# Work Order ID 92858

Item Name: Crosstube Turning Detail

<b>DART AEROSPACE LTD</b>		<b>Work Order:</b>	9285E
<b>Description:</b> Crosstube Assembly (205/212/412 High Fwd)		<b>Part Number:</b>	D212-664-141
<b>Inspection Dwg:</b> D212-664-141 <b>Rev:</b> D		<b>Page 1 of 2</b>

DRAWING NO. D212-664-141	TITLE XTUBE ASSY (205/212/412 HI FWD)	REV. D	DART AEROSPACE LTD ENGINEERING ORDER		D.E.O. NO. D212-664-141-D-1	SHEET NO. SHEET 1 OF 2	SCALE NTS
DRAWN	CHECKED	MFG. APPR.	APPROVED	DE APPR.			
DATE 11.04.07	DATE 11.04.11	DATE 11.04.12	DATE 11/04/12	DATE 11.04.12

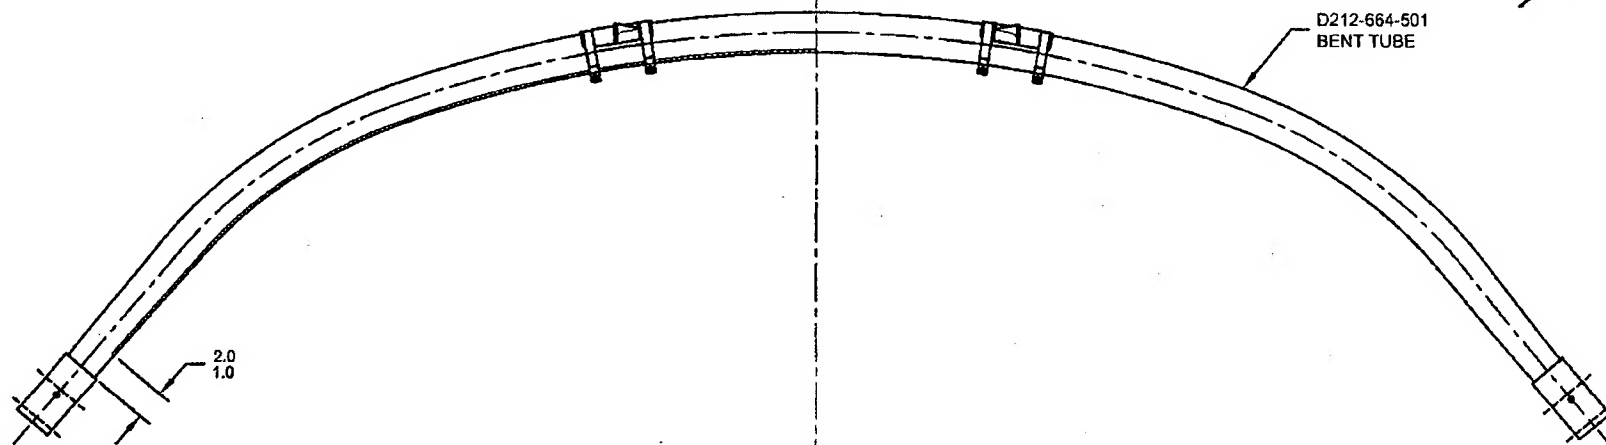
**PURPOSE:**

ADD AN INSPECTION WINDOW TO UNDERSIDE OF CROSSTUBE.

NOTES 2 OF SHEET 1 IS AMENDED AS FOLLOWS:

**IS:**

**WAS:**
